Septic Pump test - clean only
(anytime)

SEWAGE DISPOSAL SYSTEM

HOWARD COUNTY HEALTH DEPARTMENT

RE: Kneeland Property
Sand Mound Design Plan
Brighton Dam Road
Tax Map 34 Parcel 299

HYDRAULIC PROFILE
N.T.S.

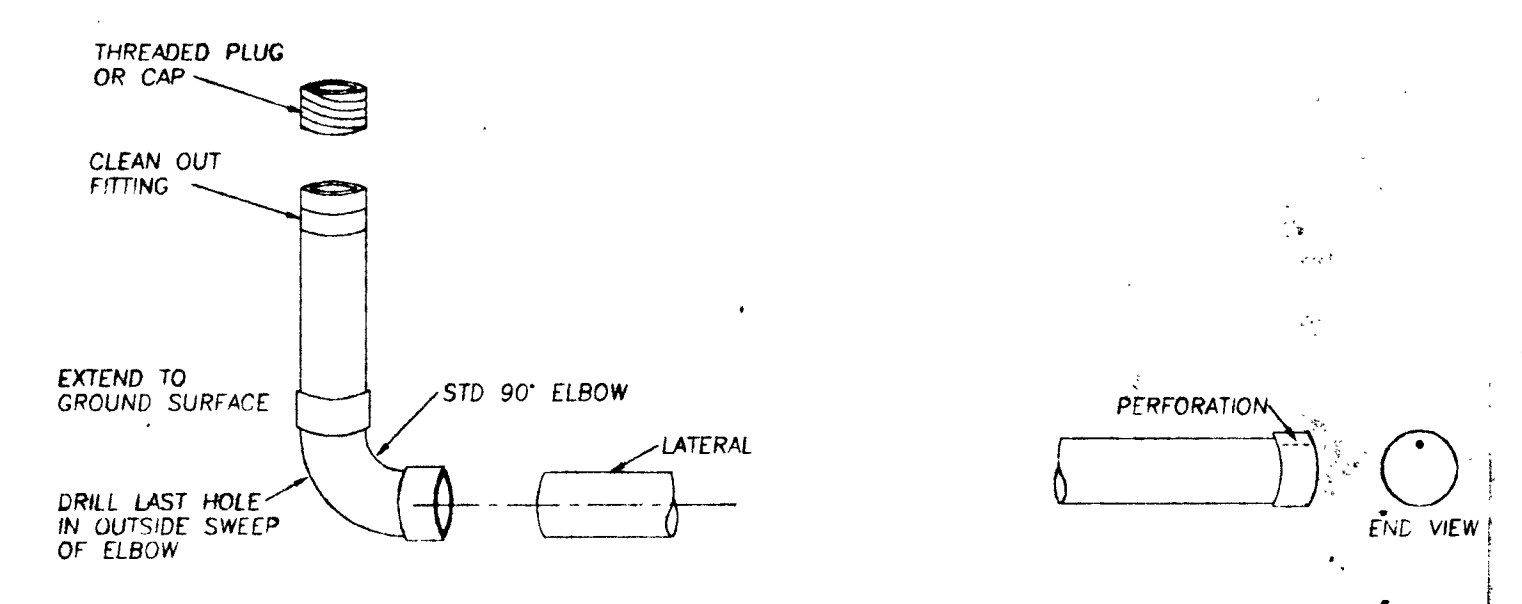
- 8) Since the revised house location suggests, and wording in Tank Installation – Note 7 so directs, uniform slope of the force main from sand mound back to the pump chamber, the Hydrolic Profile should be revised accordingly to show this uniform slope (it has a dip in the present detail).

1.250 GALLON PUMP CHAMBER (TOP SEAM)
N.T.S.

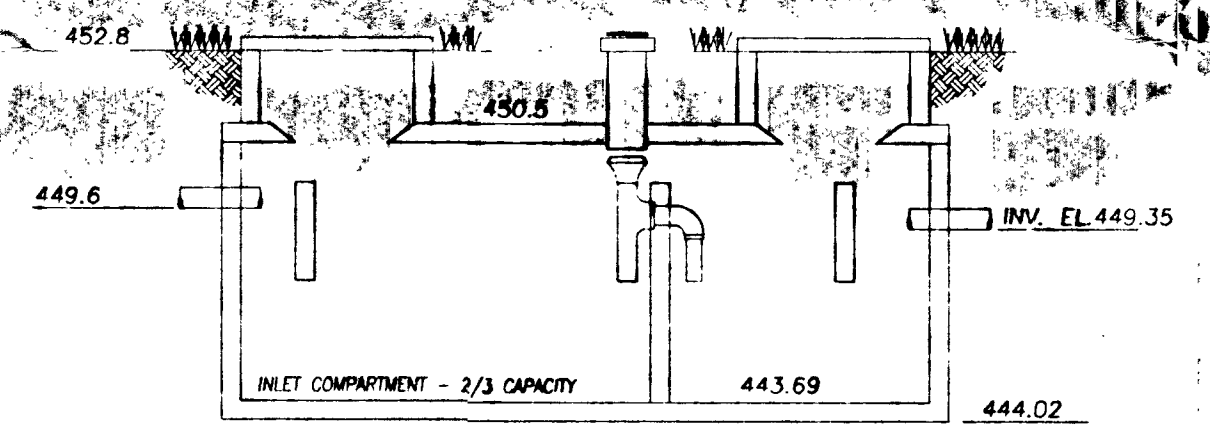
- 6) Since this plan is for a 4 bedroom house and a single pump is proposed, and as the interior dimensions give in the detail seem to suggest, specify a pump chamber at least 1250 gal in size.

LATERAL DETAIL - TYPICAL
N.T.S.

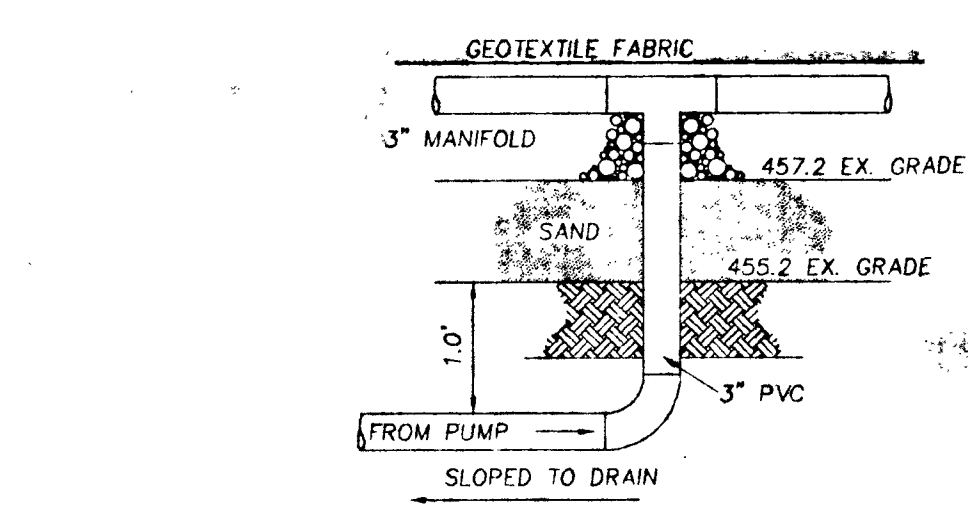
- 3) In Lateral (detail) – show a schematic of the actual Lateral Design, explicitly show:
 - a) The total # of perforations in each lateral and
 - b) The total length of each lateral (here or in Mound Layout/ Central Manifold Distribution Network Detail).

- 9) Since you're doing the rest of these revisions, please include circles representing the 3 lateral pipes (cross section) within the gravel bed and show the 6 inch minimum between lateral invert and bottom of gravel bed.

MOUND LAYOUT
CENTRAL MANIFOLD DISTRIBUTION NETWORK
N.T.S.

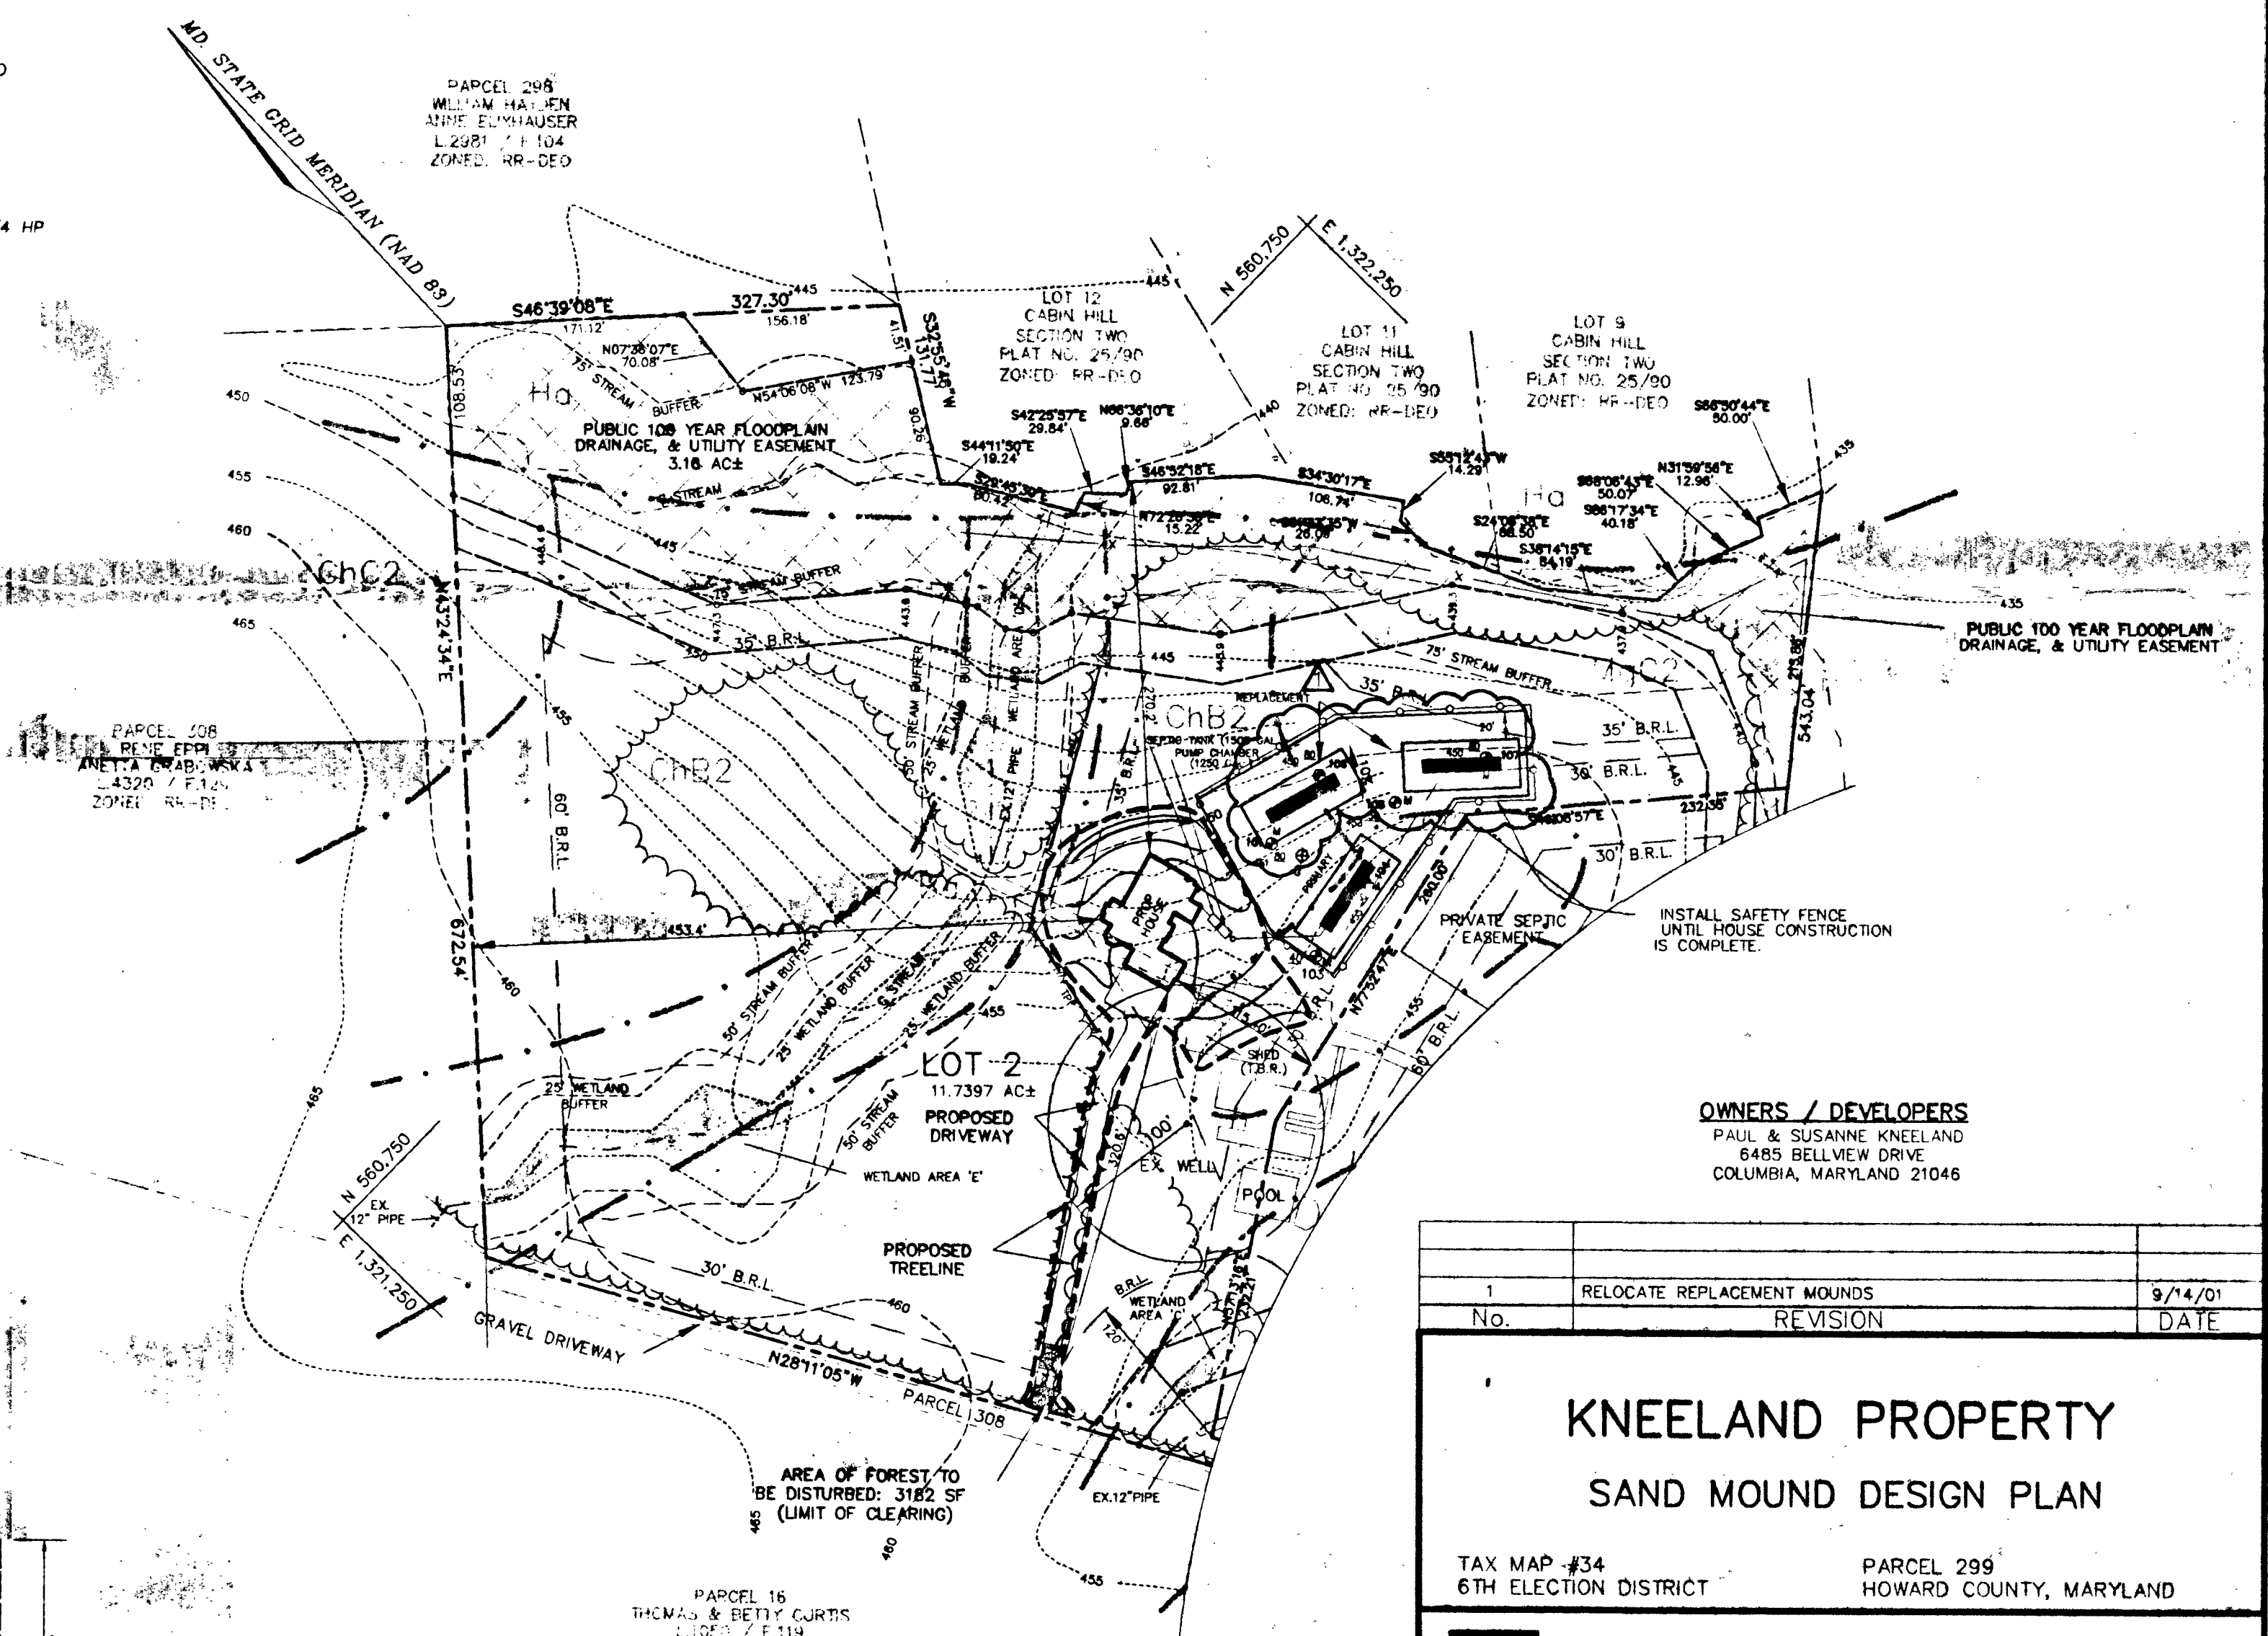
- 4) In Mound Layout Detail show the total sand mound length.

HYDRAULIC PROFILE
N.T.S.

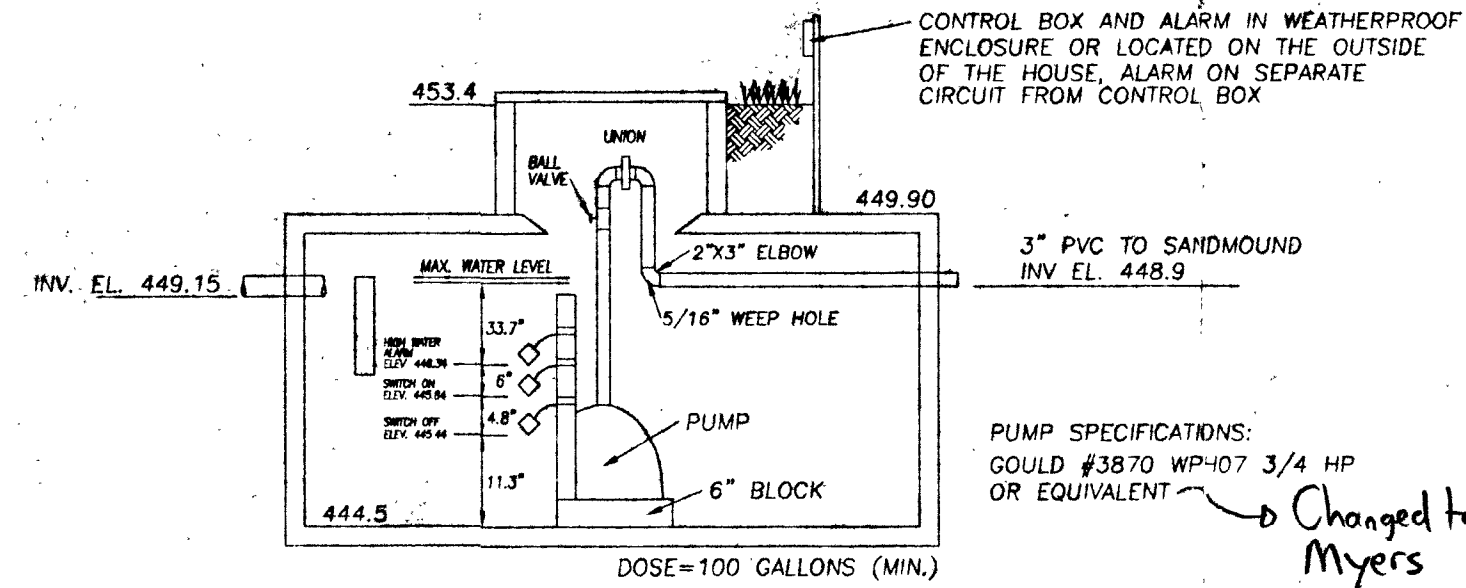
- 8) Since the revised house location suggests, and wording in Tank Installation - Note 7 so directs, uniform slope of the force main from sand mound back to the pump chamber, the Hydrolic Profile should be revised accordingly to show this uniform slope (it has a dip in the present detail.).

1,250 GALLON PUMP CHAMBER (TOP SEAM)
N.T.S.

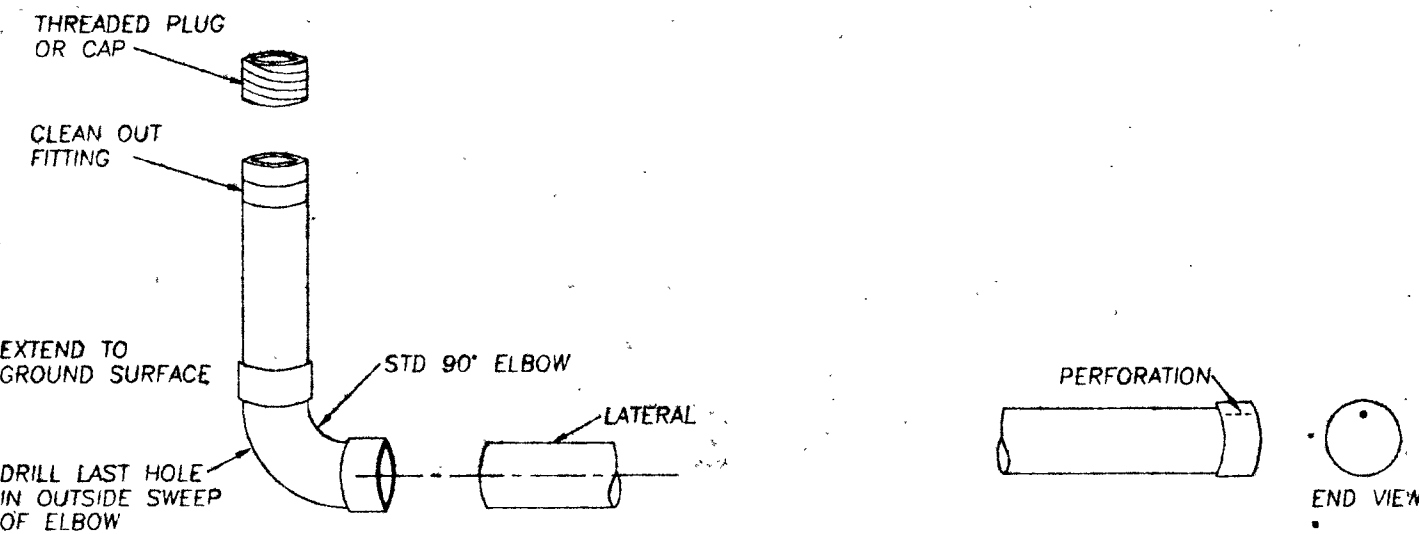
- 6) Since this plan is for a 4 bedroom house and a single pump is proposed, and as the interior dimensions give in the detail seem to suggest, specify a pump chamber at least 1250 gal in size.

LATERAL DETAIL - TYPICAL
N.T.S.

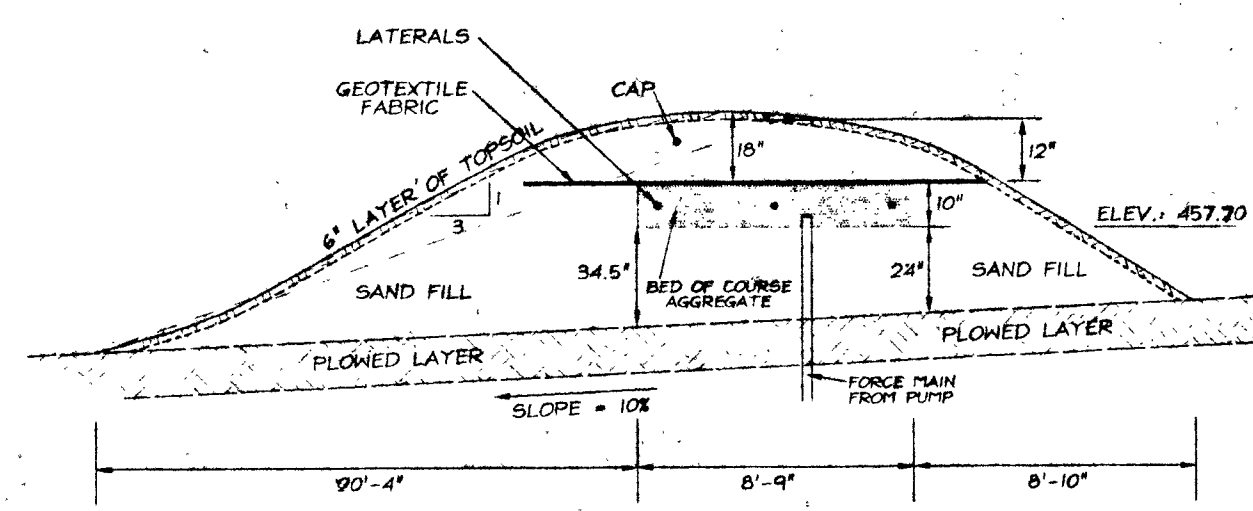
- 3) In Lateral (detail) – show a schematic of the actual Lateral Design, explicitly show:
 - a) The total # of perforations in each lateral and
 - b) The total length of each lateral (here or in Mound Layout/ Central Manifold Distribution Network Detail).

- 9) Since you're doing the rest of these revisions, please include circles representing the 3 lateral pipes (cross section) within the gravel bed and show the 6 inch minimum between lateral invert and bottom of gravel bed.
